PHILCO

PHILCO MODEL: C-5690(HR)

CIRCUIT CHANGES

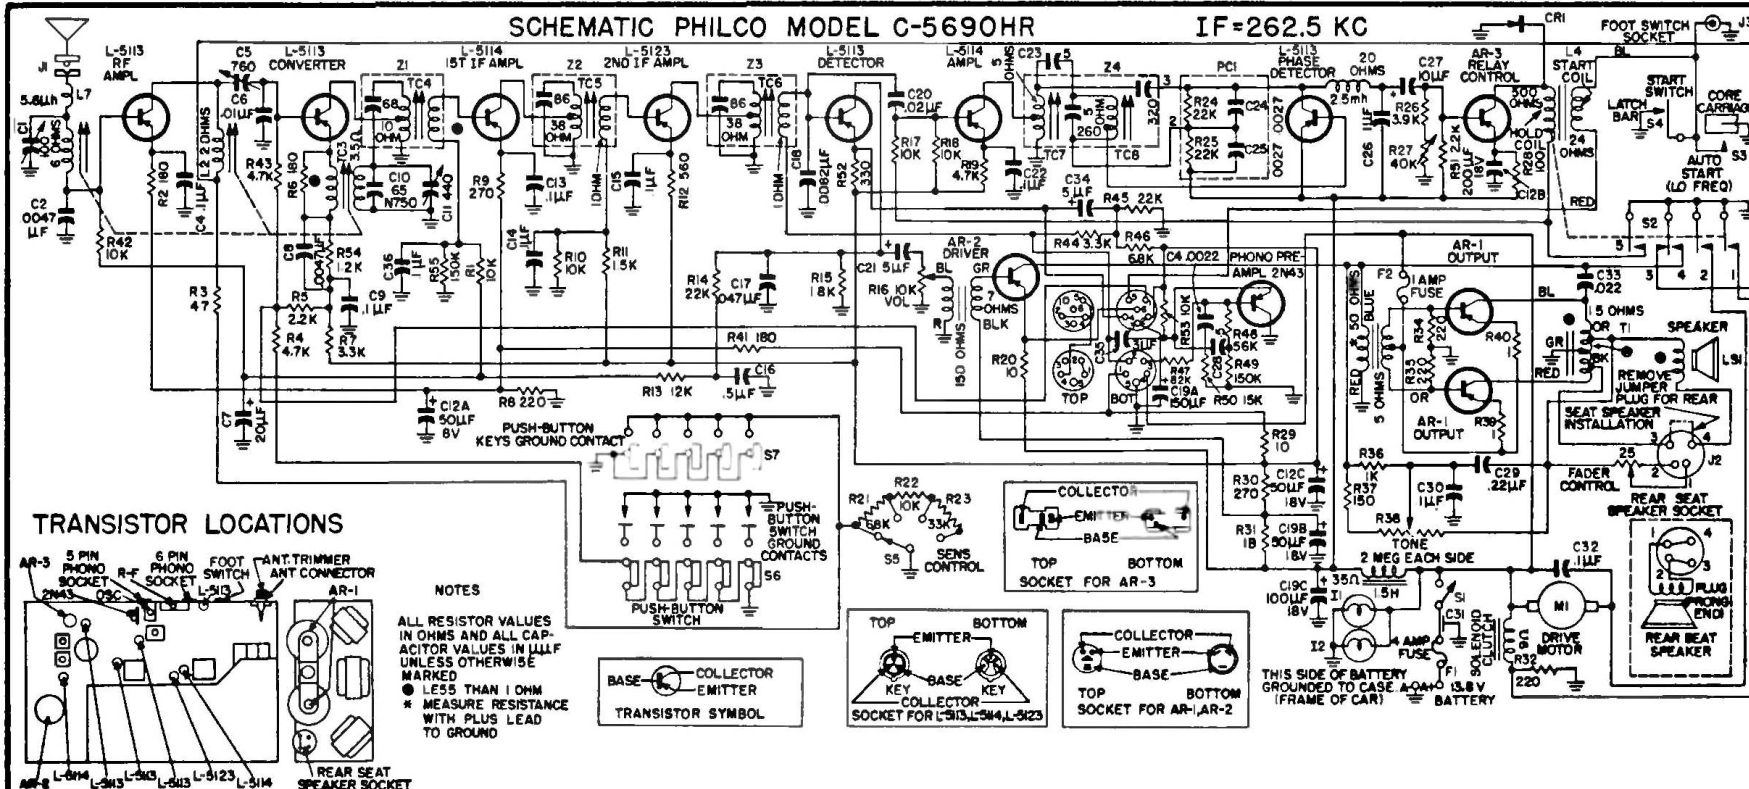
Resistor R55 was changed from 150,000 ohms to 220,000 ohms, part No. 66-4228340.

Resistor R45 was changed from 22,000 ohms to 82,000 ohms, part No. 66-3828340.

A 47-ohm, $\frac{1}{2}$ -watt resistor, part No. 66-0478340, was added between emitter detector transistor L-5113 and the junction of R52 C35. A .1- μ fd capacitor, part No. 30-1260, was added between the emitter of Detector Transistor L-5113 and ground.

Resistor R15, was changed from 1.8K to 2.7K \pm 10%, part No. 66-2278340.

Resistor R29 was changed from 10 ohm \pm 5% to 8.2 ohms \pm 5%, part No. 66-9823260.

Resistor R23 was changed from 33,000 ohms to 10,000 ohms, part No. 66-1038340.
